CHANGE ORDER NUMBER: 2HNTB Corporation
Round Rock1. CONTRACTOR: QA Construction Services Inc.Project: Great Oaks WLRelocation2. Change Order Work Limits: Sta. 502+25 to Sta. 512+27

CHANGE ORDER NUMBER: 2

Project # Great Oaks WL Relocation-3185

Change Order No. 2

SHEET
C-205
9 of 14

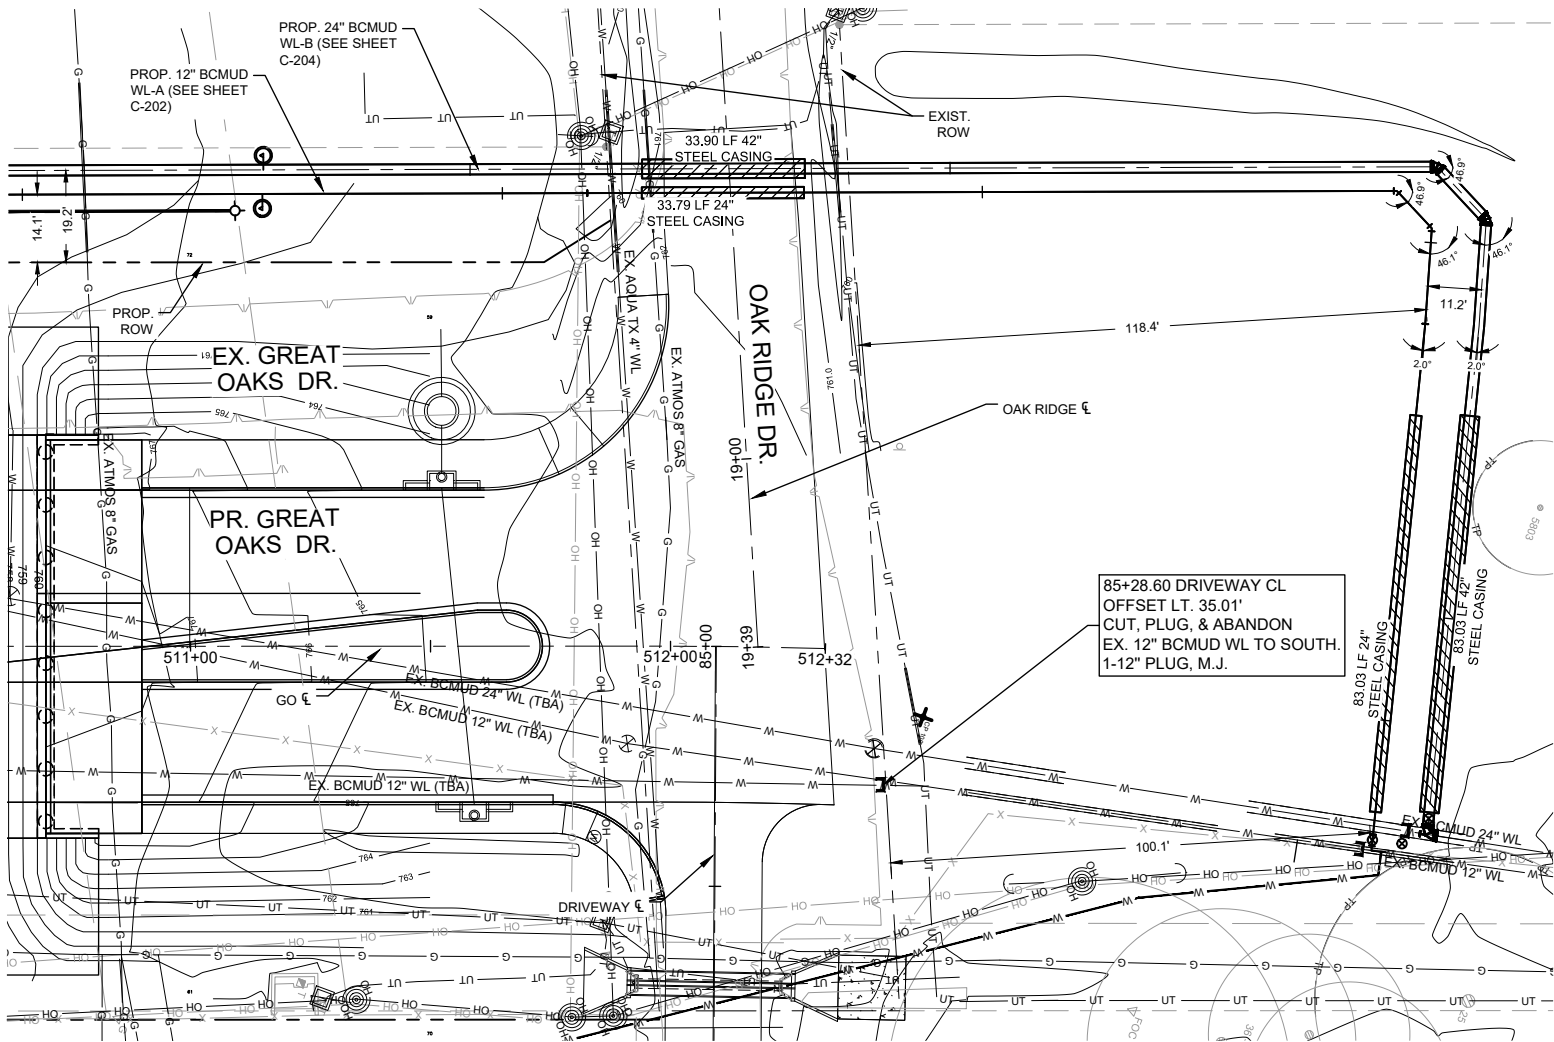
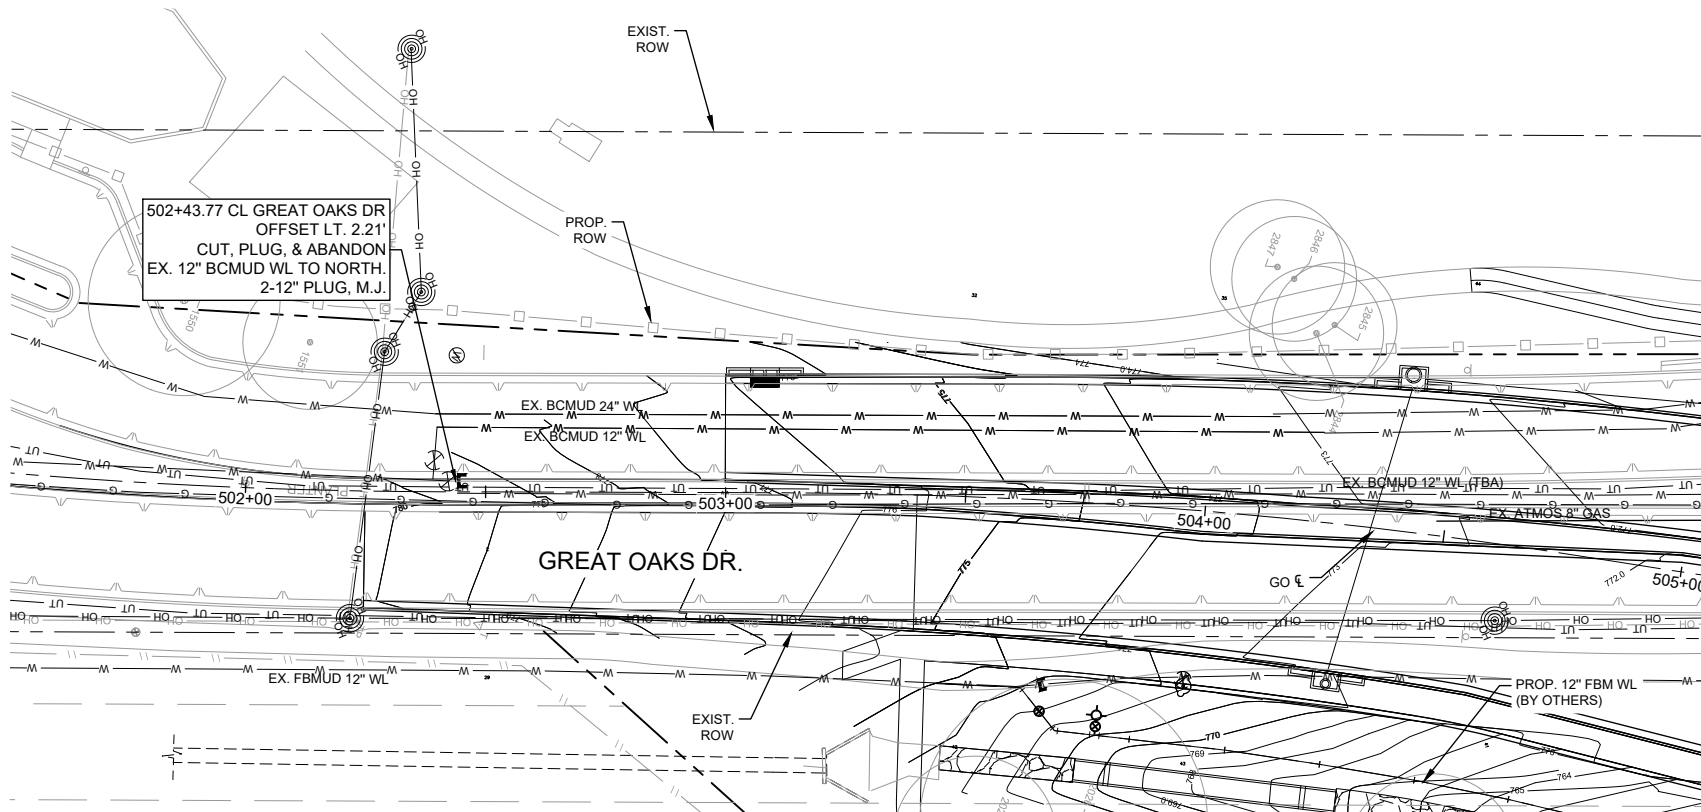
This Change Order adds revisions to the Brushy Creek MUD water line design that did not make it into the original plans. These revisions include changes requested by the Brushy Creek MUD (BCMUD) to the water line alignment for the 12" and 24" pipe north of Oakridge Drive. The BCMUD also requested to change the size of Water Line C from 4" to a 6" water line, add pipe restraint on the existing 3" water line and the addition of a 6" Pressure Release Valve Assembly (PRV). These changes are necessary, because the specification for minimum size water line is 6 inches.
